From: [Euan Bruce](#)
To: [Enquiries](#)
Cc: [Daniel Lamond](#); info@nathanverri.com; [Euan Bruce](#); [Kel Bruce](#)
Subject: Nathan Verri - 24 Mudlo Street, Port Douglas - Application for Operational Works Permit - Response to IR
Date: Friday, 24 August 2018 4:23:29 PM
Attachments: [Response to IR.pdf](#)
[Mudlo St Civil Rev D Signed 180823.pdf](#)
[Statement of Compliance.pdf](#)
[Design Report.pdf](#)

Re Council Ref: OP 2694/2018(864598)

N D Verri
Mudlo Villas, Lot 60 PTD20911, 24 Mudlo Street, Port Douglas
Application for Operational Works

Response to Information Request (IR)

Figure 2 – Pedestrian Safety Sight Lines

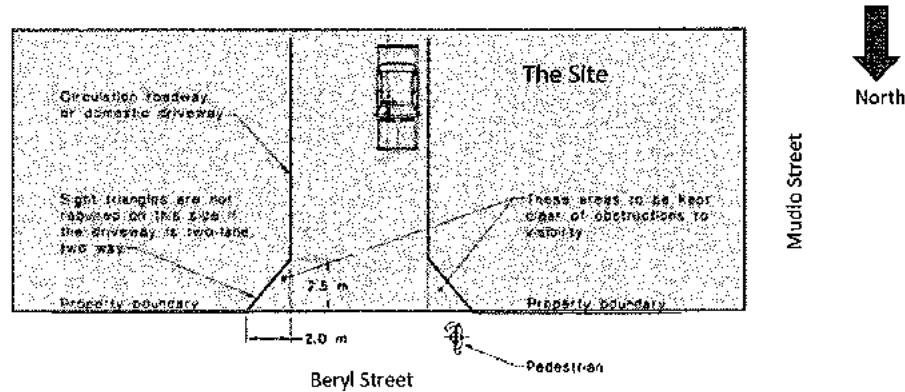
It is understood that the proposed boundary fence will not meet these requirements and therefore convex mirrors are proposed to be installed on driveways at the property boundary interface to provide the required visibility.

The proposed boundary fence does not meet the standard requirements for pedestrian safety sight lines, however the applicant proposes to introduce convex mirrors at each driveway on the boundary line so that appropriate visibility is provided. These mirrors shall be safety mirrors manufactured for outdoor use, of an industrial quality unbreakable acrylic, have crystal clear viewing, have weather-proof fibre-glass backing and be appropriate for traffic / blind spot outdoor applications.

**GENERAL ARRANGEMENT
 DRIVEWAYS AND PATHWAY**

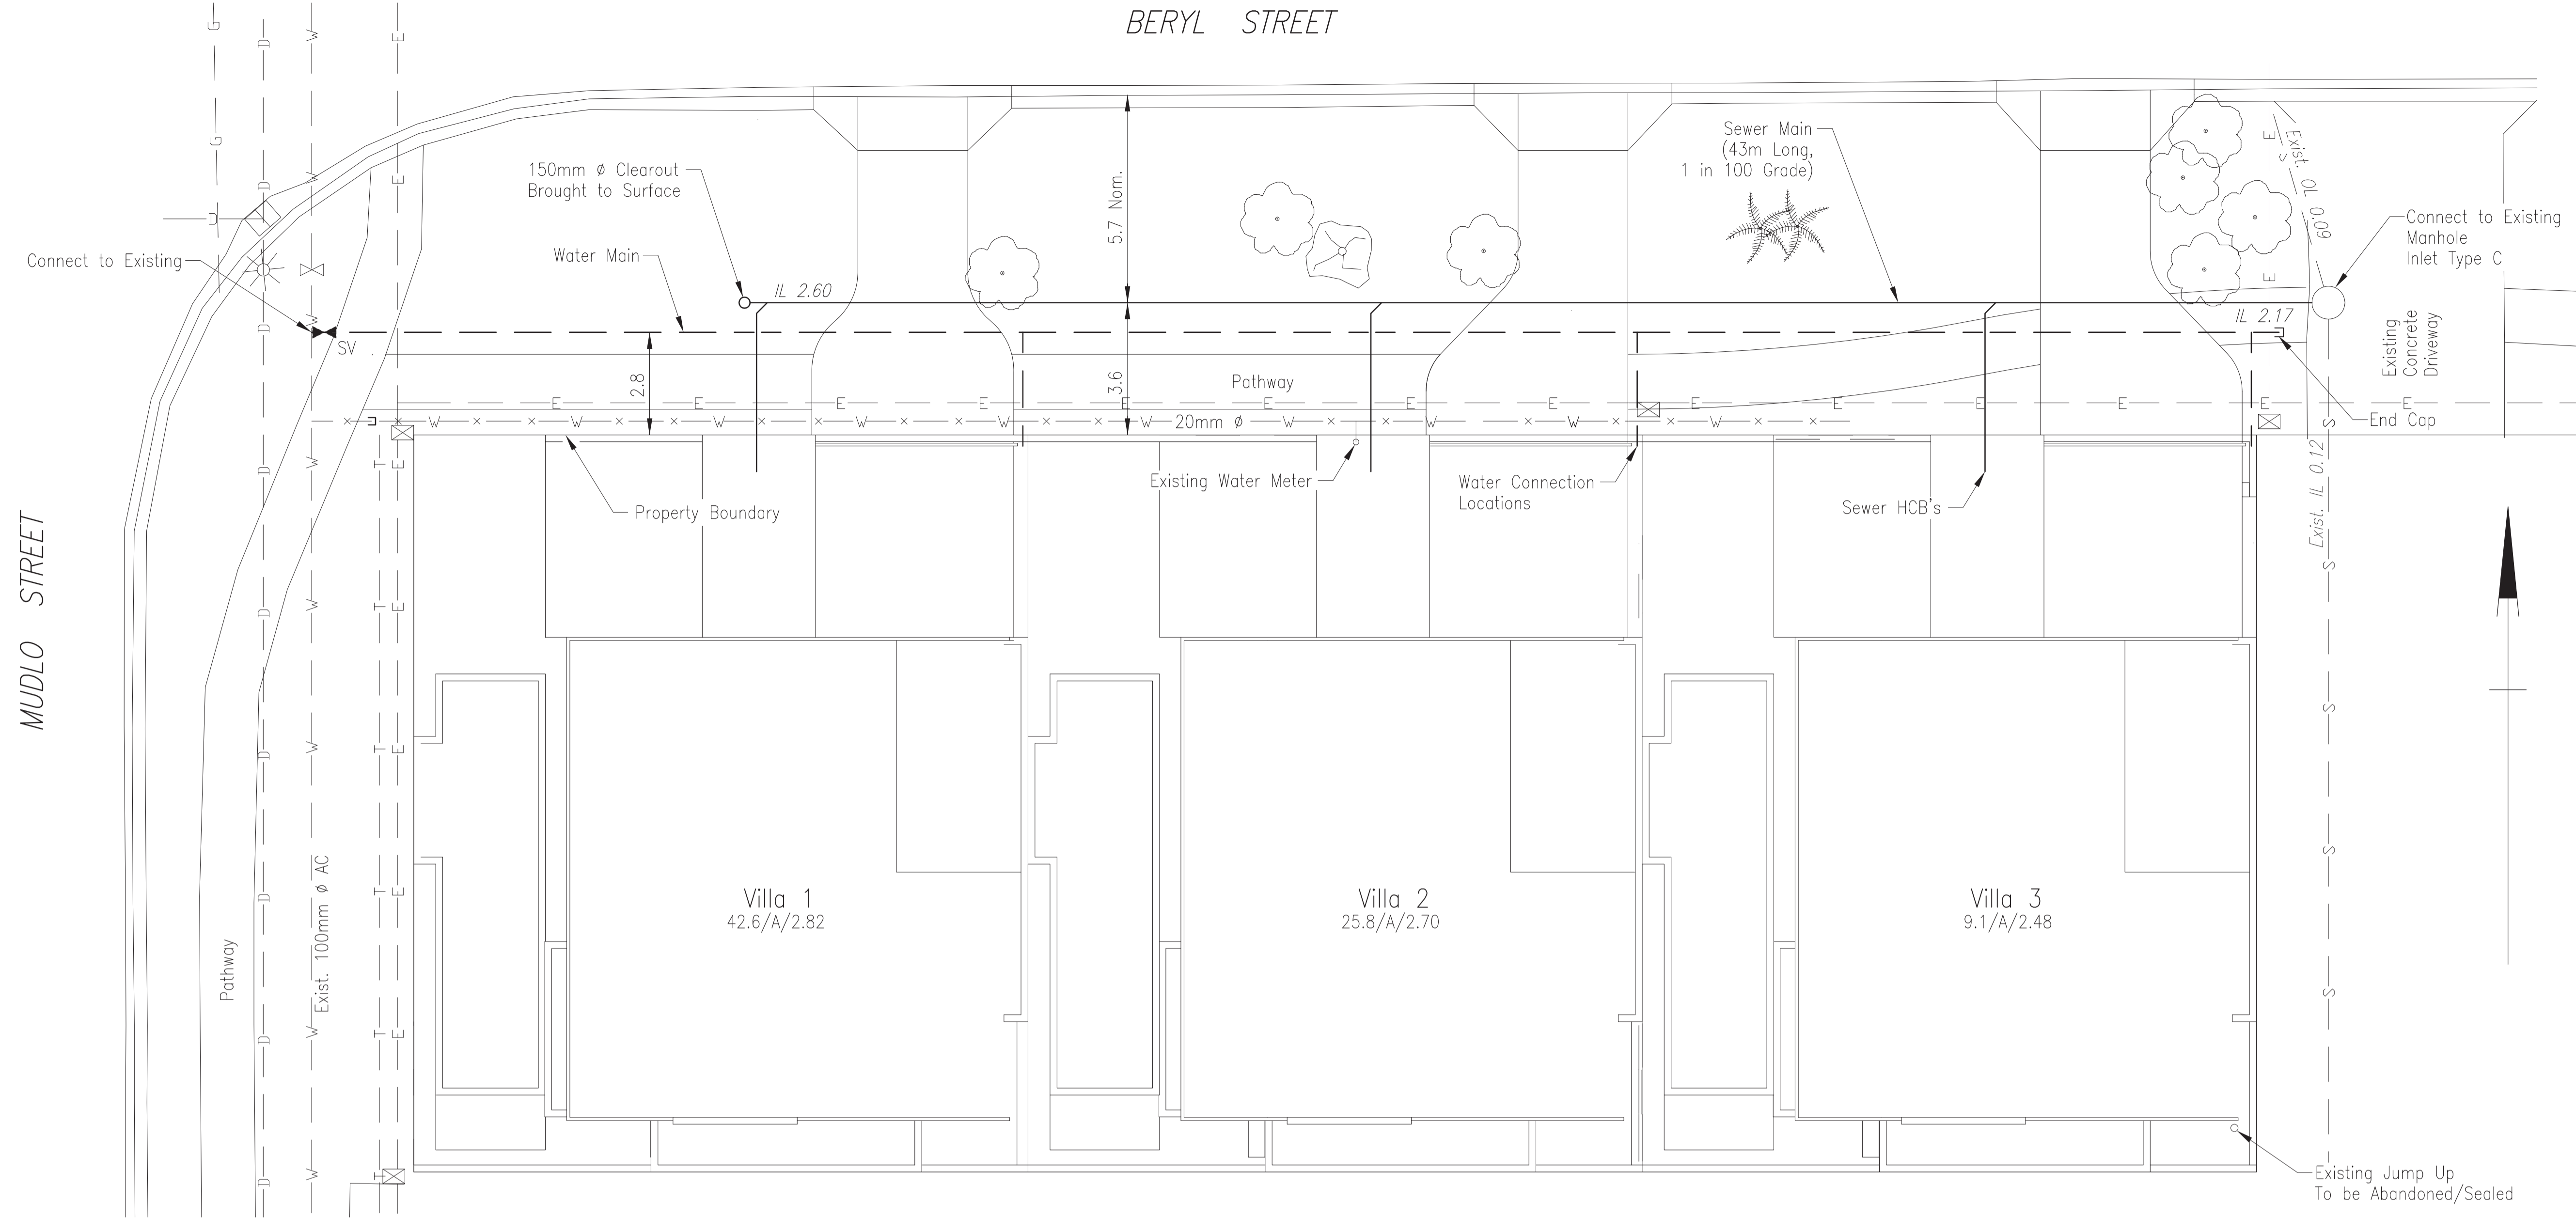
9. Drawing K-3649 Sheet C01 D has been amended to provide a complete cut out of the kerb in the crossover construction.
10. The driveway width has been dimensioned (3.0m) on drawing K-3649 Sheet C01 D. The grading(s) adopted for the design of the three driveways has been chosen to minimise verge re-shaping, enable retention of existing trees/palms and result in a satisfactory landscape outcome.

11. Drawing K-3649 Sheet C01 D has been amended to detail the removal of the disused driveways and restoration of the verge.
12. Drawing K-3649 Sheet C01 D has been amended to detail a 2.5% crossfall on the Beryl Street footpath.

13. Levels have been detailed on Drawing K-3649 Sheet C01 D so as to provide appropriate mobility access at the Mudlo St/ Beryl St pathway intersection.

**WATER / SEWERAGE
 RETICULATION AND
 EXISTING SERVICES**

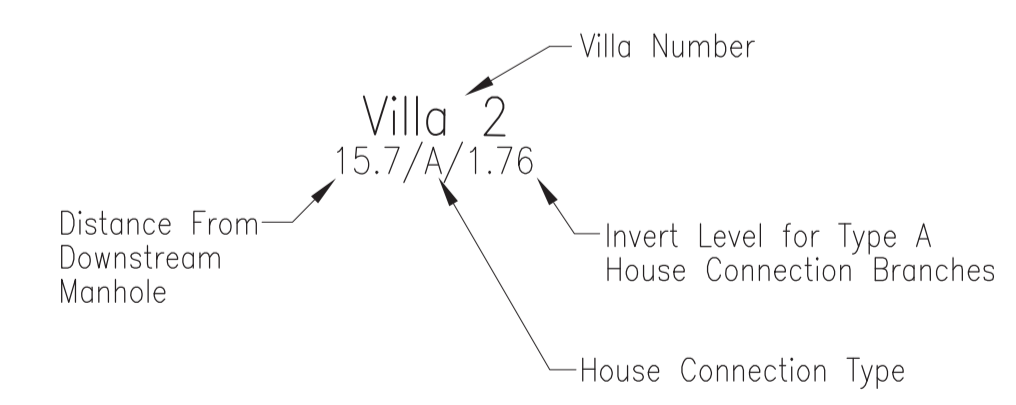
5. The dimensions shown on Drawing K-3649 Sheet C02 C detail a separation distance of 0.688m between the water and sewer mains (assuming 150 uPVC gravity sewer and 63mm OD water main).

7. We have amended the water main size to be 63mm OD (50mm dia HDPE water main class 12 solvent weld jointed).

8. The sewer detail provided on drawing K-3649 Sheet C02 D complies with the requirements of FNQROC and preliminary advices received from Council included the recommendation that a manhole was not required at the end-of-line.
Refer: DSC email to Gilboay Hydraulic Solutions , 30 Jan 2017.
